<b>Office Action Summary</b>	<b>Application No.</b>	<b>Applicant(s)</b>	
	10/796,144	OHASHI ET AL.	
	<b>Examiner</b>	<b>Art Unit</b>	
	Alfred Joseph Wujciak III	3632

This is the first Office Action for the serial number 10/796,144, RESERVOIR THAT A BRACKET IS INTEGRATED WITH, filed on 3/10/04.

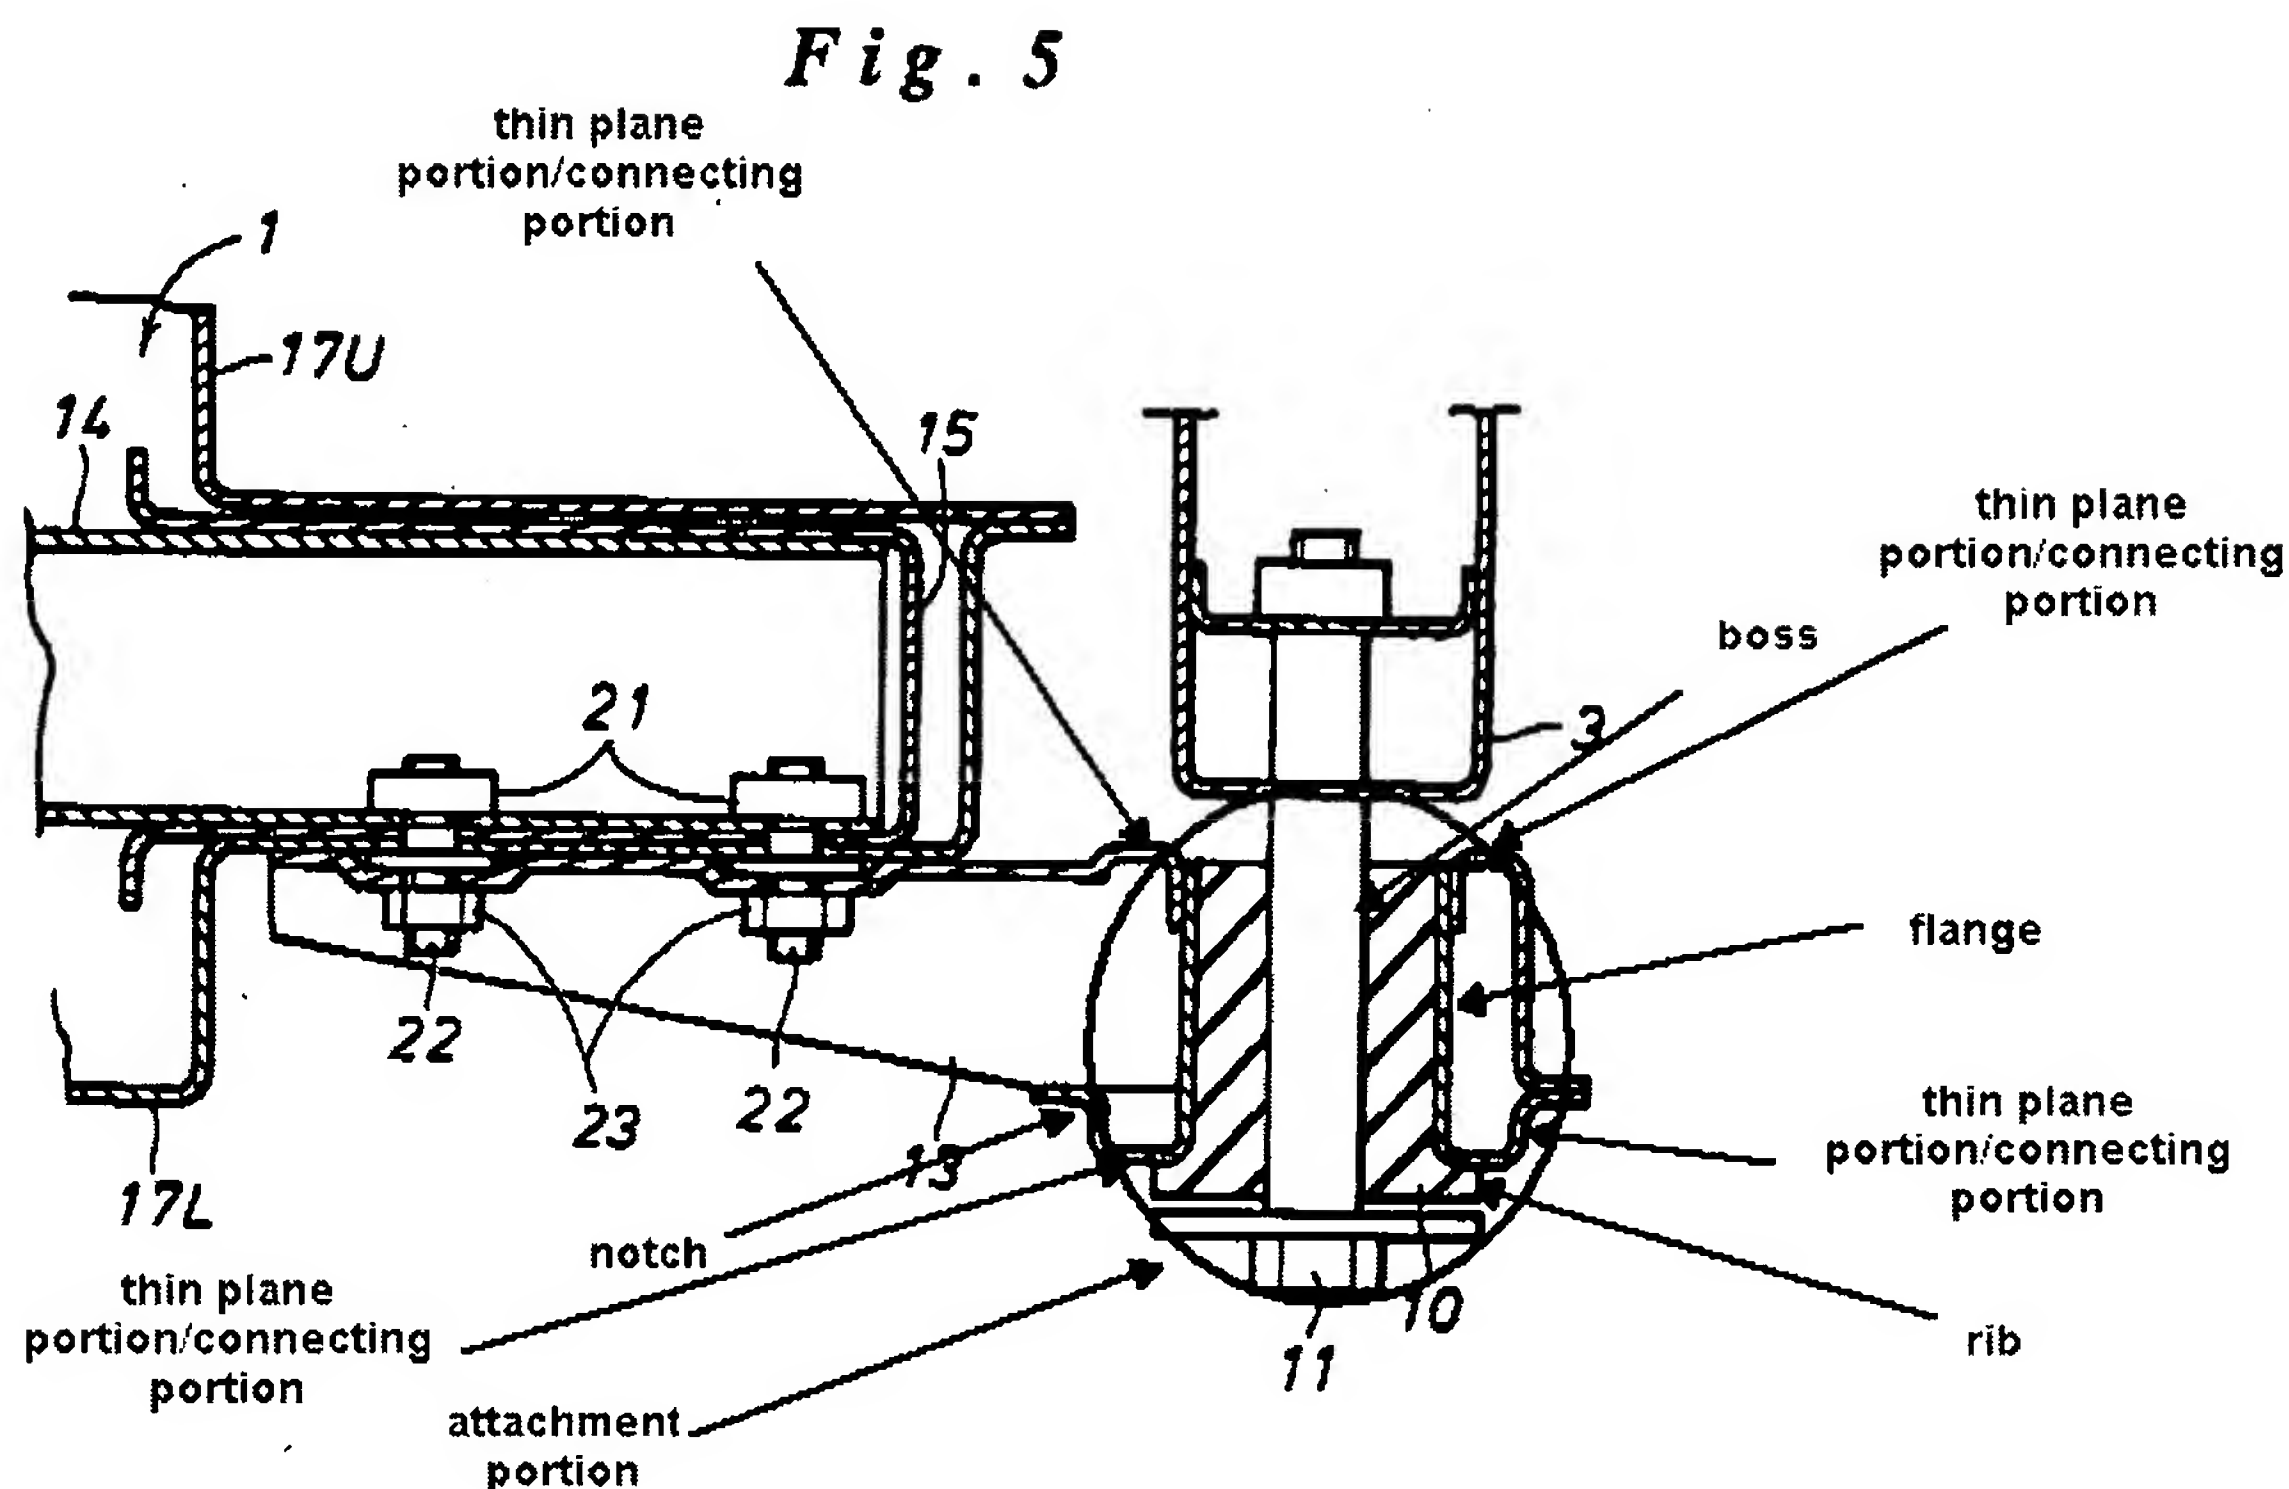
Claim 10 is rejected under 35 U.S.C. 102(b) as being anticipated by US Patent # 5,890,740 to Kami.

Kami teaches a reservoir comprising a tank (1), a bracket (13) integrated with the tank and an attaching portion/absorbing means arranged with bracket. The attaching portion comprises a boss (11) for fixing to the vehicle (3) and flange portion arranged around the boss portion and connected to the tank. The reservoir further includes connection portion comprising notch (see drawing below). The reservoir includes first and second brackets (figure 2) having first and second attaching portions.

*Fig. 5**Response to Arguments*

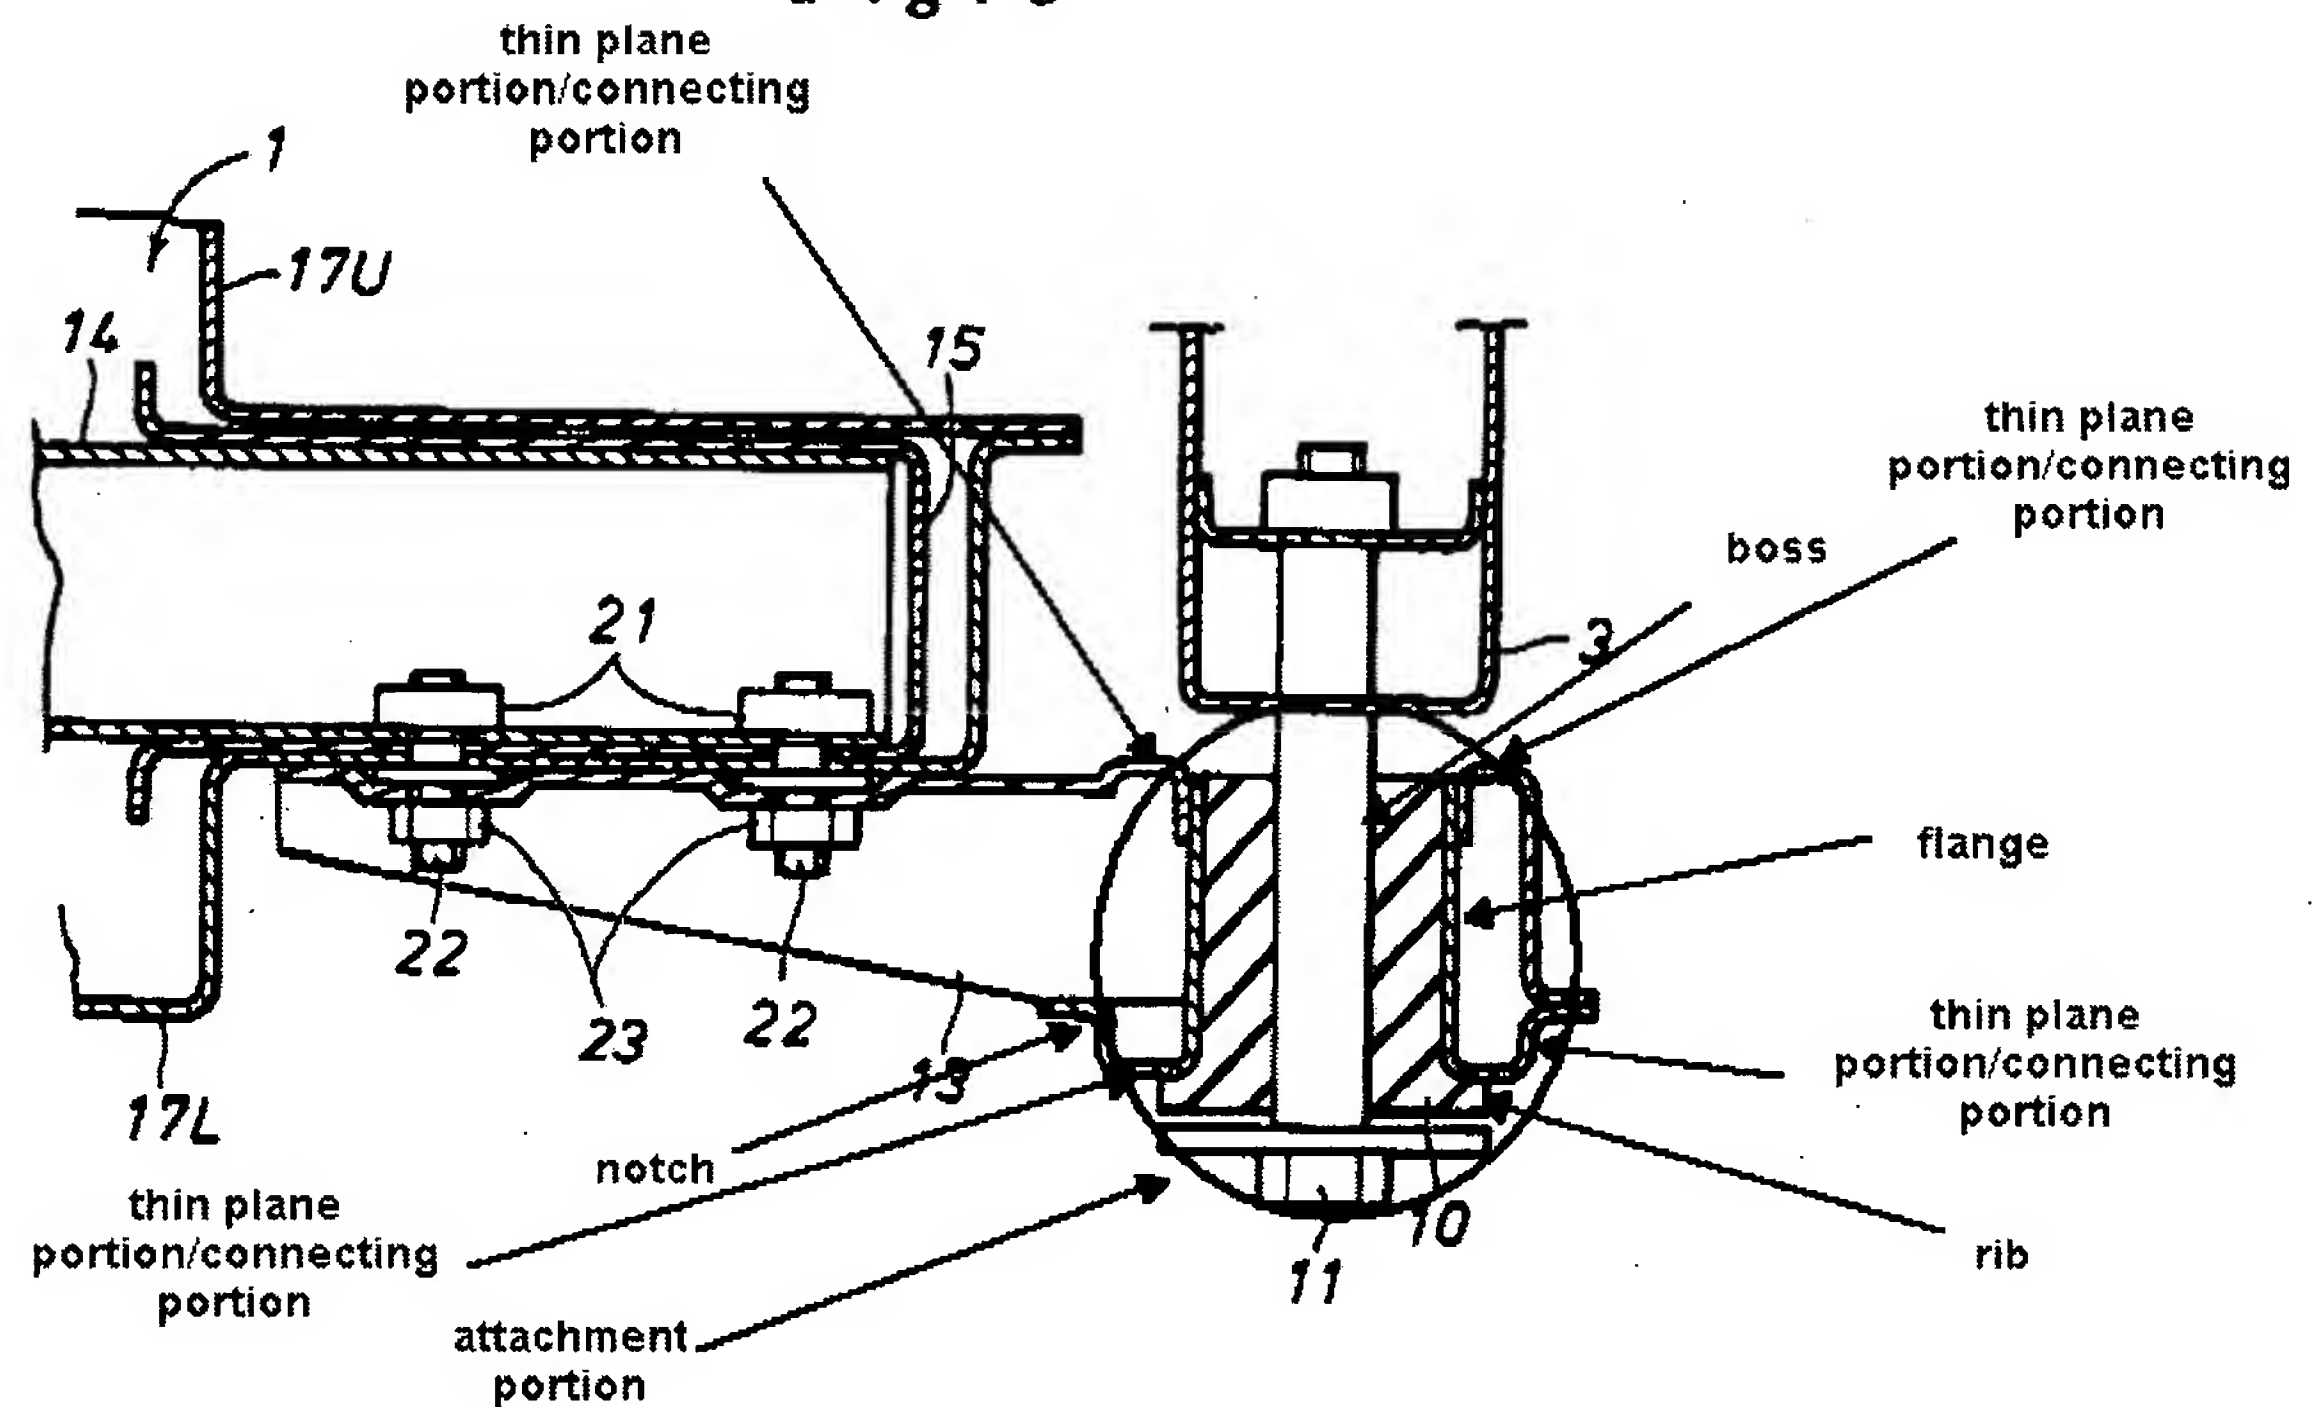
Claims 5, 6, 11 and 12-14 are rejected under 35 U.S.C. 103(a) as being unpatentable over Kami in view of US Patent # 4,223,899 to Krieger.

Kami teaches a reservoir comprising a tank (1), a bracket (13) integrated with the tank and an attaching portion/absorbing means arranged with bracket. The attaching portion

comprises a boss (11) for fixing to the vehicle (3) and flange portion arranged around the boss portion and connected to the tank. The attaching portion comprises a plurality of thin plane portions and the thin plane portions are arranged around the rib. The reservoir further includes connection portion comprising notch (see drawing below). The reservoir includes first and second brackets (figure 2) having first and second attaching portions (figure 5, 10-11).

Kami teaches the attaching portion comprising a rib portion and the first connecting portion comprising notch but fails to teach plural of rib portions connecting the boss. Krieger teaches plurality of rib portions (17-18) connecting boss (117-118). It would have been obvious for one of ordinary skill in the art at the time the invention was made to have added additional rib portion to Kami's boss as taught by Krieger for maintaining element 10 within the flanges.

With respect to applicant's argument stating that "Kami are not formed in a flange of an attaching portion as claimed and clearly do not suggest an thin plane portion formed in a flange so as to reduce thickness portion of the flange of the first attaching portion which is fracturable." In this office action, the examiner changed the reference numbers for thin portions and the flange. The diagram above shows the thin portions formed in flange. The flange is located adjacent to vertical and rib part of element 10. Regarding the term of "fracturable", the flange

has the ability of being fracturable by bending and breaking at certain stress/strain point due to external impact on the vehicle or long period of vibration.
